## ***Interactive comment on “Vulnerability of groundwater resources to interaction with river water in a boreal catchment” by A. Rautio et al.***

A Author Comment.

Anonymous Referee #2

Fig. 1.

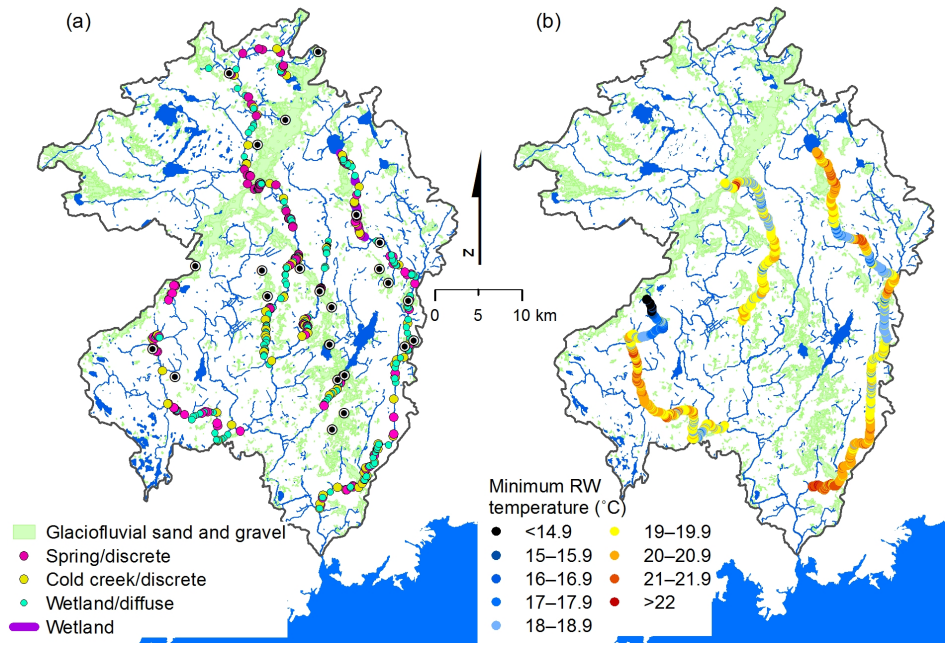
P2447 L11-16 – This paragraph is difficult to understand. I read figures in a way that

point 0 is the river outlet, so the river flows from 20km (left) to 0 km (right). This doesn't agree with you wording telling that artificial GW cools the river water. Instead we see a sudden warming. Please clarify what you mean by distance upstream and to which direction does the river flow?

This was unclearly marked in figures and we have corrected that. We have added distance from upstream on the X-axis and arrow to clarify the river flow direction.

Fig. 2.

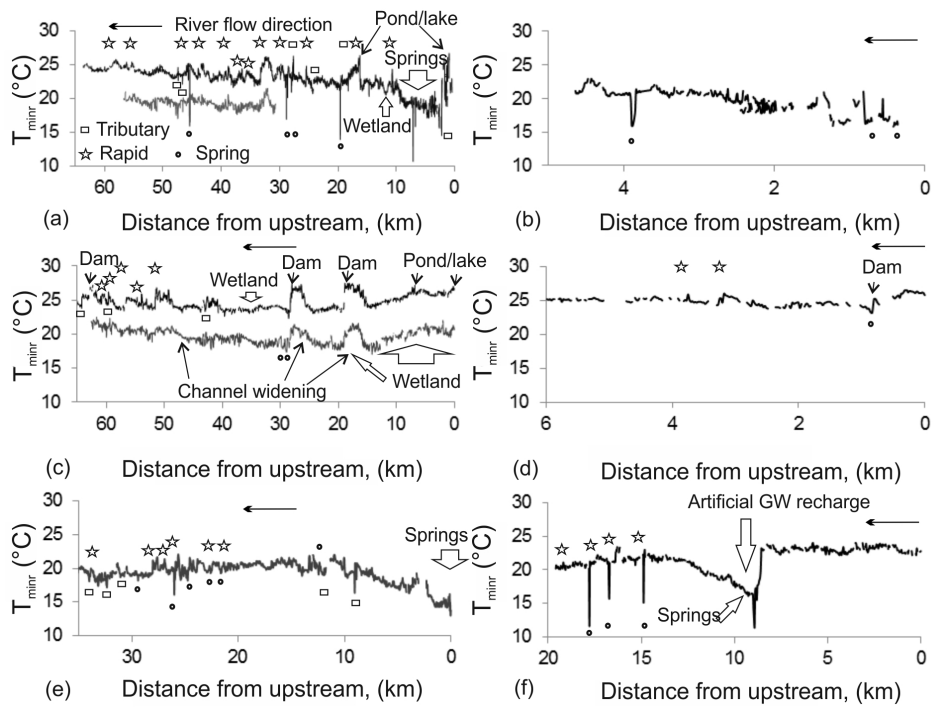
P2448-2449 – interpretation of figs. 6 and 7 is quite confusing. In many occasions I'm not sure to which of the subplots the authors are referring to. Perhaps consider dividing the data into more plots, instead of trying to fit in too many subplots. Or at least please refer to the letter of subplot more actively.

We have made improvements into the figures (increased font size) and referred more precisely to the figures.
